Brooklyn Inland Wetlands Commission
Regular Meeting Agenda
Tuesday, November 14, 2023
Zoom and In-Person Meeting
Clifford B. Green Memorial Center
69 South Main Street
6:00 p.m.

**SITE PLAN MODIFICATION FOR
SPECIAL PERMIT # 22-007
FOR WEDDING/EVENT VENUE FOR
WILLOW HILL LLC
459 WOLF DEN ROAD
BROOKLYN, CONNECTICUT
DATED: SEPTEMBER 29, 2023
REVISED: NOVEMBER 8, 2023**

RE: Job #22172
Response to Engineer's Review
Special Permit for
459 Wolf Den Road
Brooklyn, CT

ENGINEERING PLAN AND DRAINAGE REPORT REVIEW PERTAINING TO PROPOSED WILLOW HILL EVENTS WEDDING/EVENT VENUE (ASSESSOR'S MAP 19, BLOCK 18 - LOTS 18A & 18B) WOLF DEN ROAD BROOKLYN, CT (November 1, 2023)

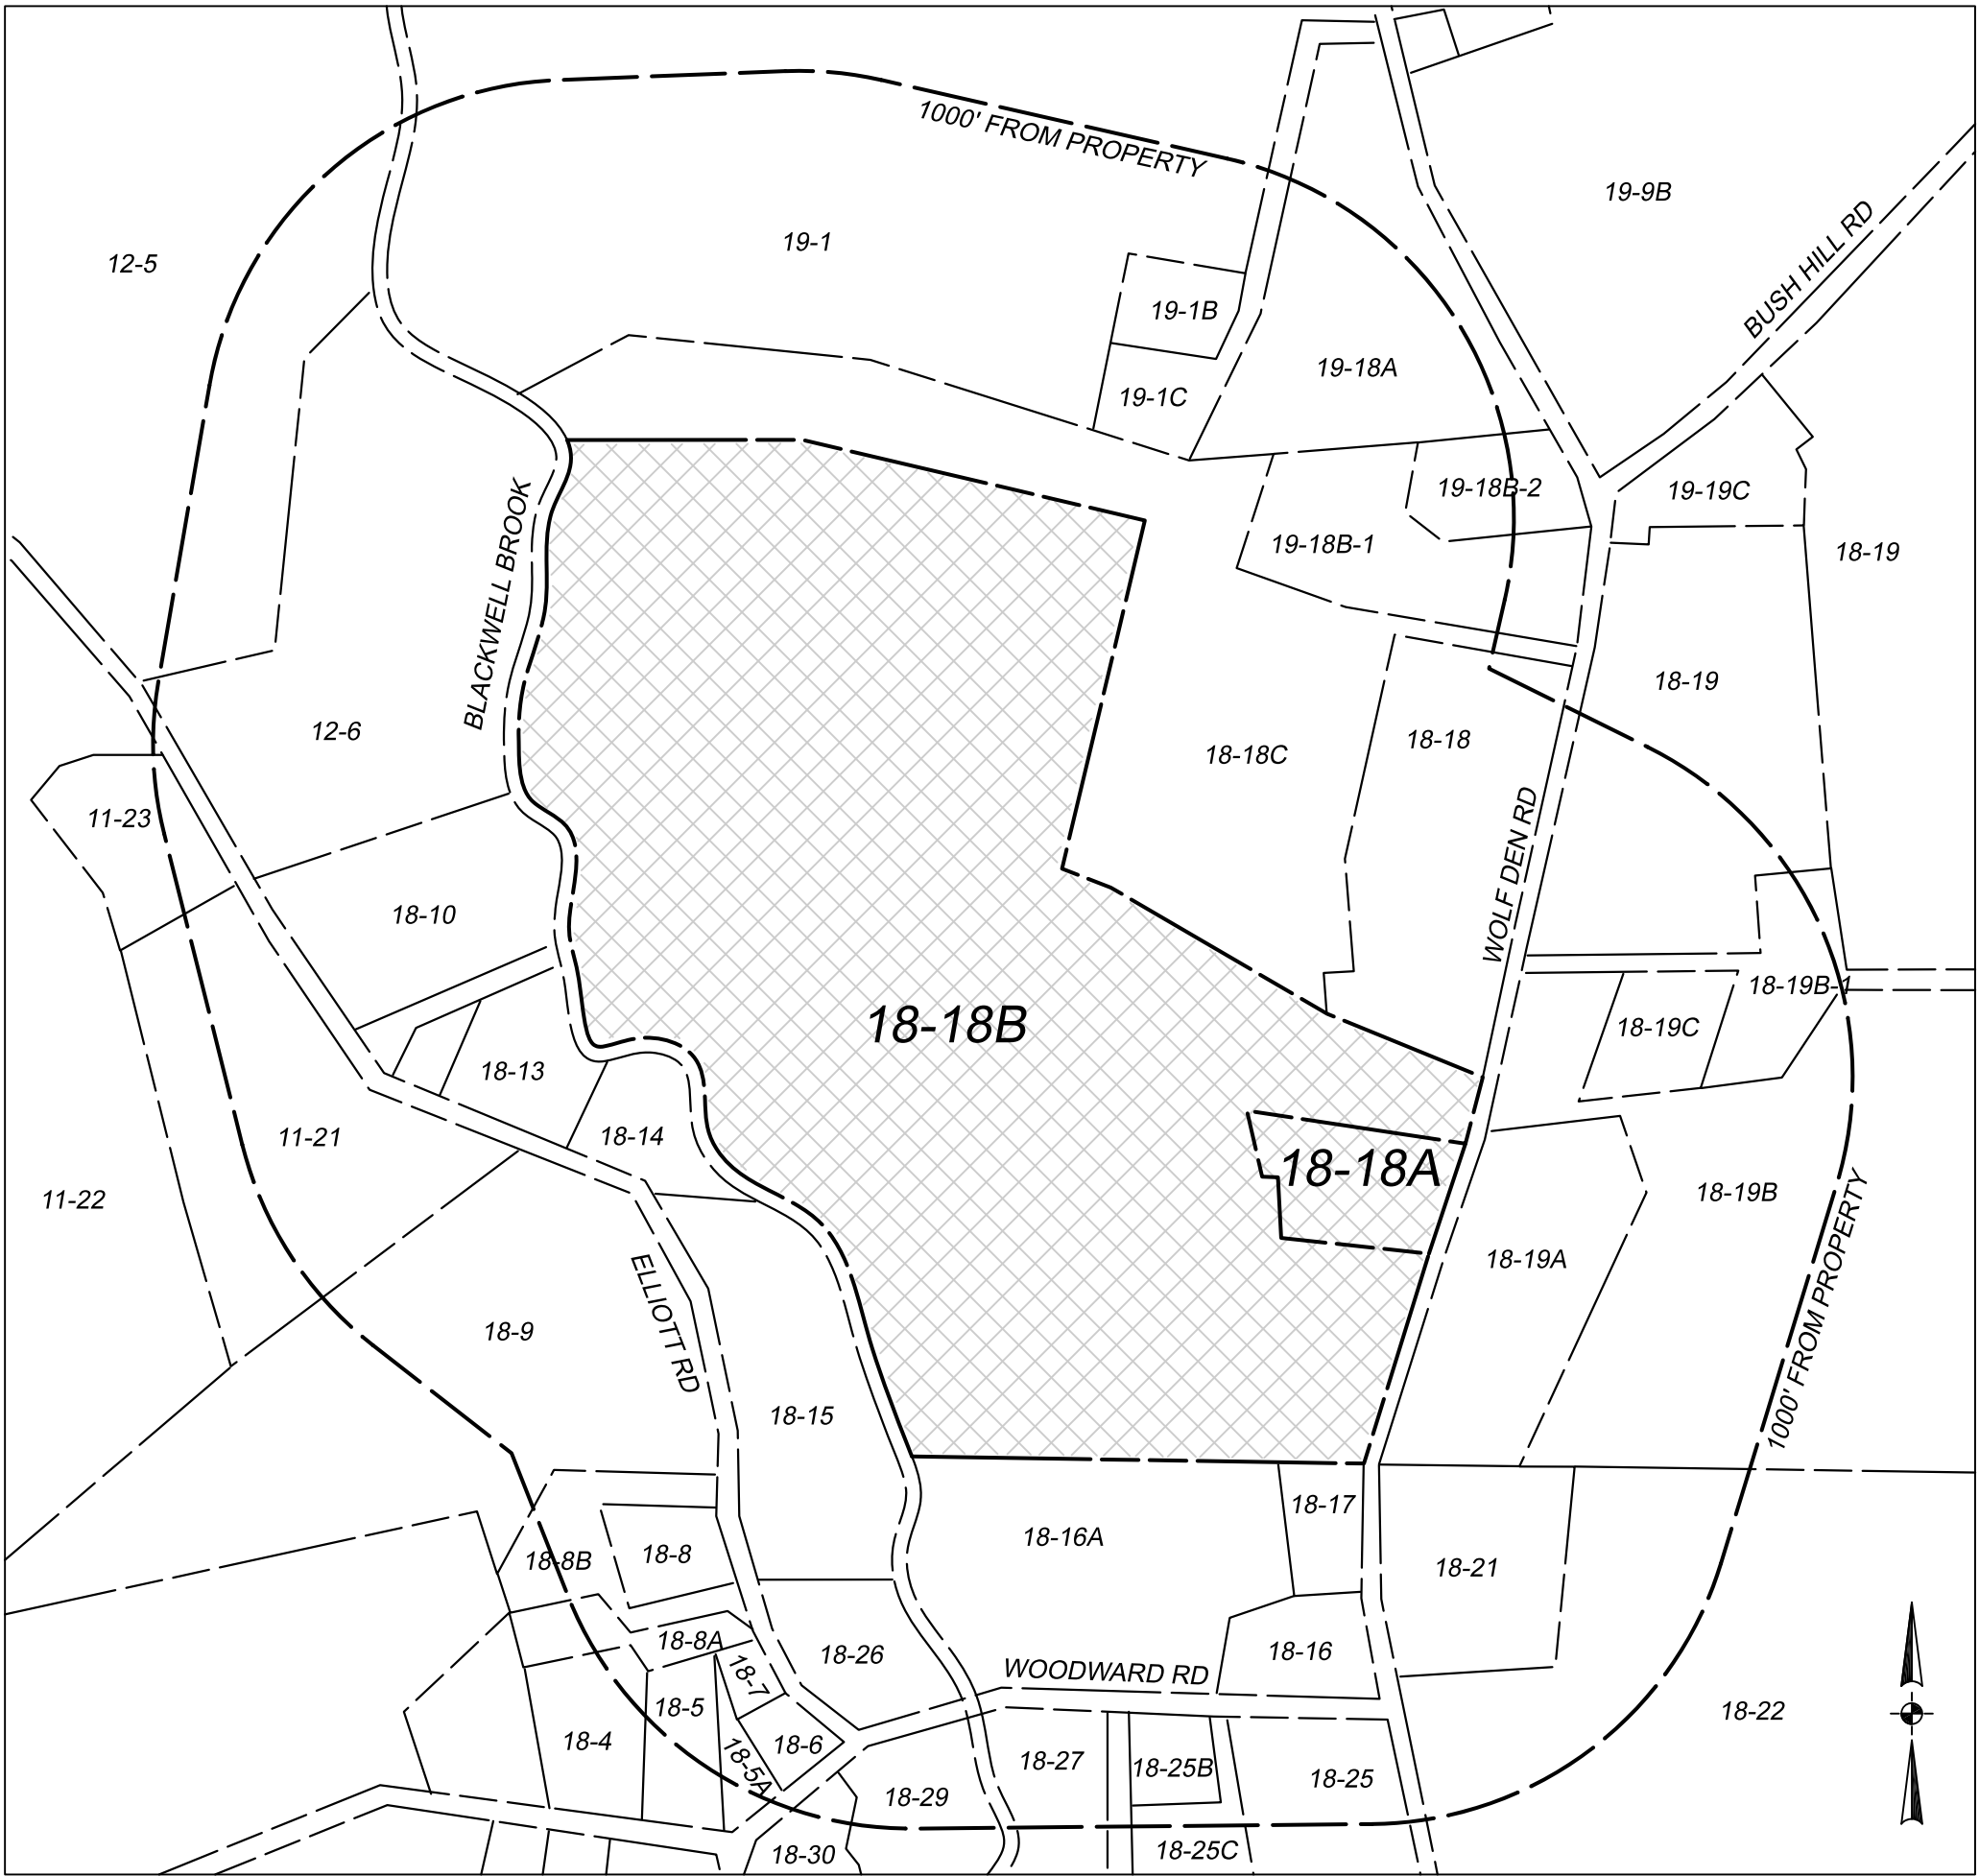
Cover Sheet – Sheet 1 of 5

1. A "north arrow" needs to be included in the "Location Plan."
2. The "Parking Spaces" in the zoning information block state that there are 59 proposed spaces. However, counting spaces on Sheet 2 of 5 reveals that there are only 44 proposed spaces, two (2) of which are ADA compliant. The missing 15 spaces need to be drawn on the plan, and if existing they should be noted as such.

Cover Sheet

1. A north arrow has been added.
2. The previously approved special permit included a proposed 40 car parking lot. The current site plans also propose a 40 car parking lot. The remaining spaces are existing and located within the driveway. The number of existing and proposed spaces is not changing from what was previously approved.

ACCESS DRIVEWAY AND PARKING LOT PLAN
PREPARED FOR
WILLOW HILL LLC
459 WOLF DEN ROAD, BROOKLYN, CT
MAP 15 - LOTS 18 & 18A

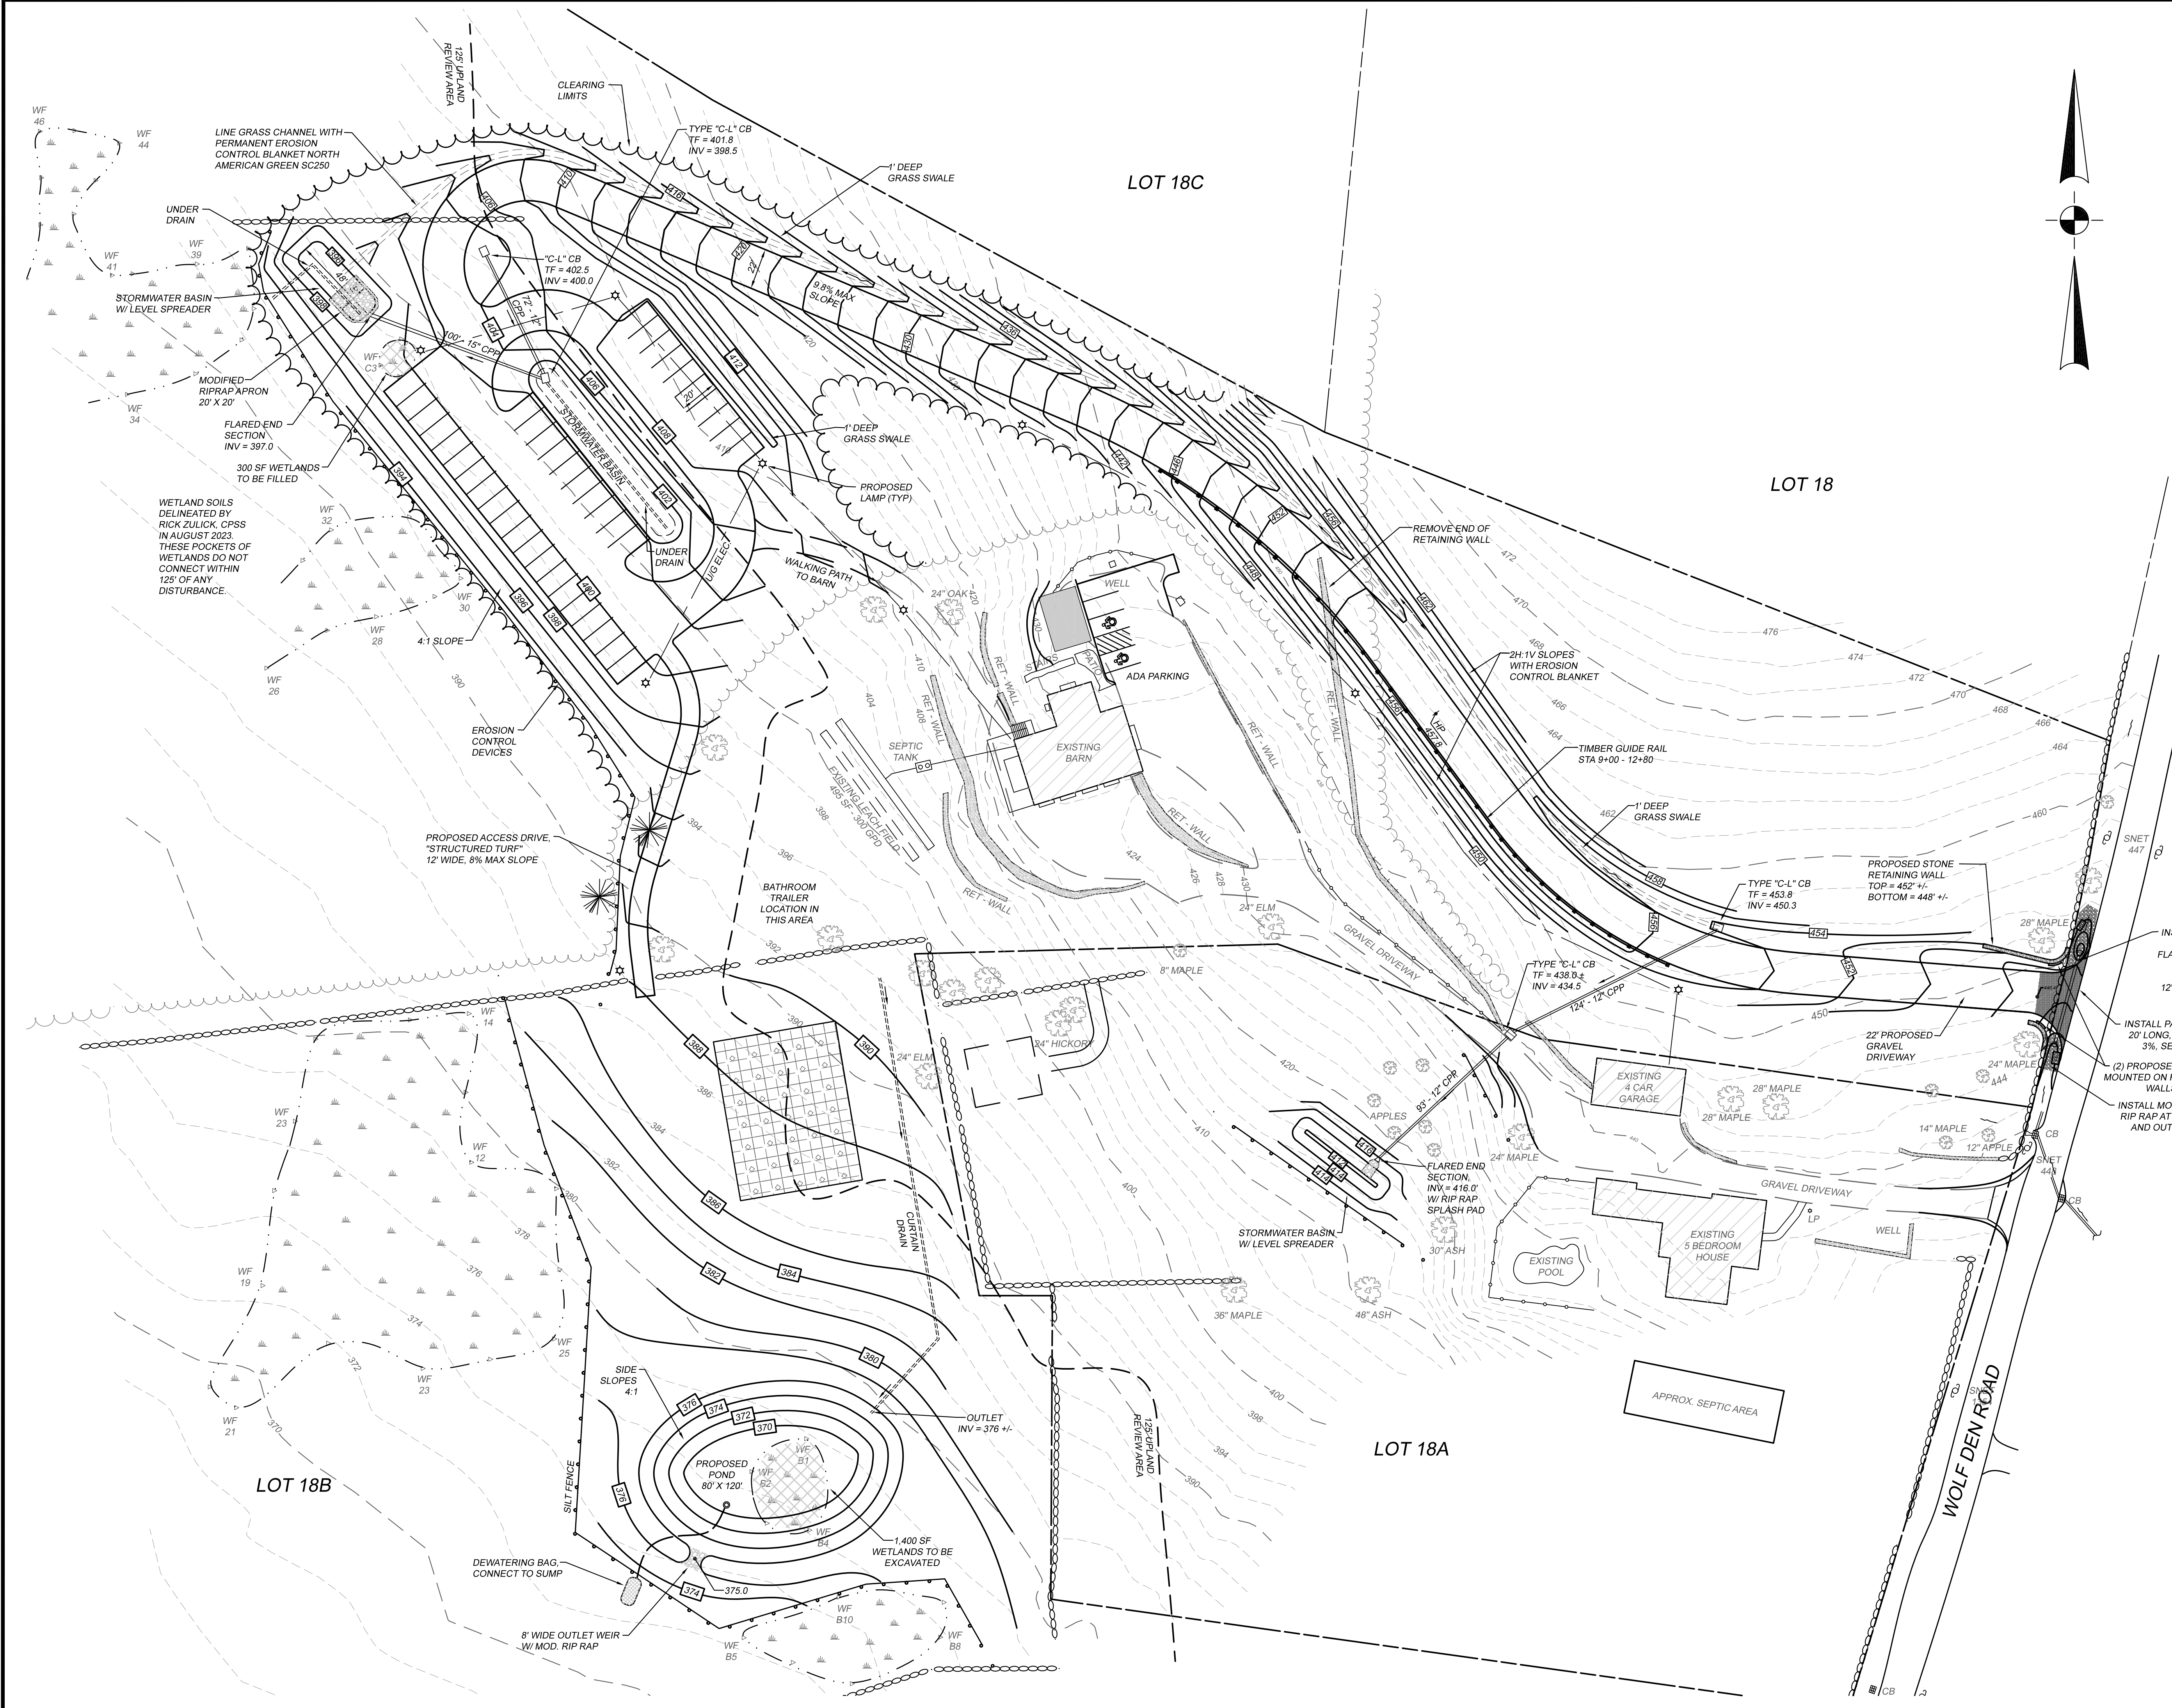
Access Driveway and Parking Lot Plan - Sheet 2 of 5 (Improperly labeled 2 of 6)

1. A "north arrow" needs to be added to the plan.
2. Wetland flags are missing between lines A, B and D and need to be added to the plan in order to accurately assess the limit of the 125' Upland Review Area. Furthermore, wetland delineation needs to be identified below the "primary tent location" to the extent of the contour lines at the bottom of the plan. However, the way the wetland limits are shown on the plan, they are most likely connected and it is unacceptable not to show them that way. Additional flagging is required and noted on the plans and the soil scientists report revised accordingly and resubmitted for review.

be specified on the plan and a construction detail showing the profile of the pad needs to be added to Sheet 5 of 5. Additionally, the erosion control system needs to be extended approximately 30 feet in both directions to capture runoff from the proposed uphill grading.

6. Dimensions are needed for the “modified riprap apron” in the “Stormwater Basin w/Level Spreader.” A construction detail specific to the apron needs to be added to Sheet 5 of 5.

8. Soil test pits are needed in each stormwater basin location to verify the seasonal groundwater table level. This is to verify that the basins will not be constructed in the water table, as they are to function as dry basins in accordance with the Drainage Report for this project. As can be seen on the plans, the bottoms of the basins will be 2-3 feet below existing ground and any standing water will invalidate the calculations in the Report.

9. The erosion control system needs to be extended to the stone wall at the stormwater basin with riprap apron.
10. The erosion control system needs to be extended to the stone wall and perhaps further along the downhill side of the “Structured Earth Access Drive.” It is unclear if the driveway will be extended beyond what is shown on the plan.

11. An additional erosion control system needs to be added to the plan in the area of widening the existing driveway at the 4-car garage.
12. An additional erosion control system needs to be added all along the downhill side of the proposed driveway, starting from Wolf Den Road.

16. The existing slope across the area where the primary tent is located is approximately 6 percent. Does this present a problem for guests and will the area ultimately need to be regarded to achieve less of a slope? Additionally, how will the tent be accessed, as this is not depicted on the plan?

19. The “temporary restroom” location needs to be added to the plan.
20. The “walking path” to the barn and other locations should consist of materials compatible to all types of footwear to minimize risk of injury due to unstable compatibility with said footwear.

21. Erosion and sediment controls need to be added below the proposed grading at the catering tent site.
22. What is to prevent water from inundating the “catering tent” if there is a heavy downpour during an event? There is no proposed grading to direct overland flow away from this critical function requiring strict adherence to safe food handling practices.

23. There is no loading/unloading zone designated for a food caterer's vehicles.
24. Enclosed dumpster locations need to be added to the plan, as it is unrealistic to think that holding up to 100± events per year will not generate trash on site.
25. A path leading to the "primary tent" location and its material specification needs to be added to the plan.
26. A symbol for a "proposed lamp" needs to be added to the "Legend."
27. Routing of proposed underground utilities is missing on the plans. Symbols for these need to be added to the "Legend."

1. A north arrow has been added.
2. Additional wetlands have been delineated and added to the plan.
3. These pockets of wetlands do not connect, at least not within 125' of any construction.
4. Pipes with smooth interiors have been specified on the detail on Sheet 4.
5. A rip rap splash pad has been added to the site plan, and a detail has also been added. Erosion controls have been extended.
6. Dimensions have been added.
7. This issue has been addressed by specifying a larger catch basin.
8. The two storm water basins have been revised to include under drains, to intercept any groundwater that could enter the basins.
9. Erosion controls have been extended.

10. Erosion controls have been added.
11. Erosion controls have been added.
12. Erosion controls have been added.
13. The driveway entrance and associated drainage has already been approved, and is not being modified. Additionally, the hole is not four feet deep, it is just over two feet deep. A 15" diameter pipe with 12" of cover would require a depth of 2.25 feet. In my opinion, it would be better to remove this pipe and have a gentle swale in the paved apron, to mimic what currently exists on the shoulder of the road in this location. However, for the previous approval, I was instructed to specify a 15" pipe in accordance with the town's driveway details. Would the town consider allowing the applicant to specify a smaller pipe, or one with less cover? If we could reduce the cover, that would allow for a shallower hole.

16. Proposed grading for the tent area, to provide a flatter pad for the tent, has been added to the site plans. The "access drive" from the parking lot will be used to load and unload the tent materials. Guests will access the tent area on foot, either from the ceremony location or the barn.

17. Previously reviewed and approved landscaping plans by Verdant Landscaping describe work to be done in this area, including the removal of a stone wall and installation of stone steps and a walking path. These site plans do not propose any changes to this area.

18. All yard boxes have been replaced with type C-L catch basins.
19. A location has been added to the plans.
20. Noted.
21. Erosion controls have been added.

23. The caterer vehicles will be unloaded in the two parking spaces near the handicap spaces.
24. The caterer will be responsible for removing all trash at the conclusion of each event. This was previously approved and is not being modified.

26. A lamp symbol has been added to the legend.
27. Underground utilities have been added to the plans and legend.
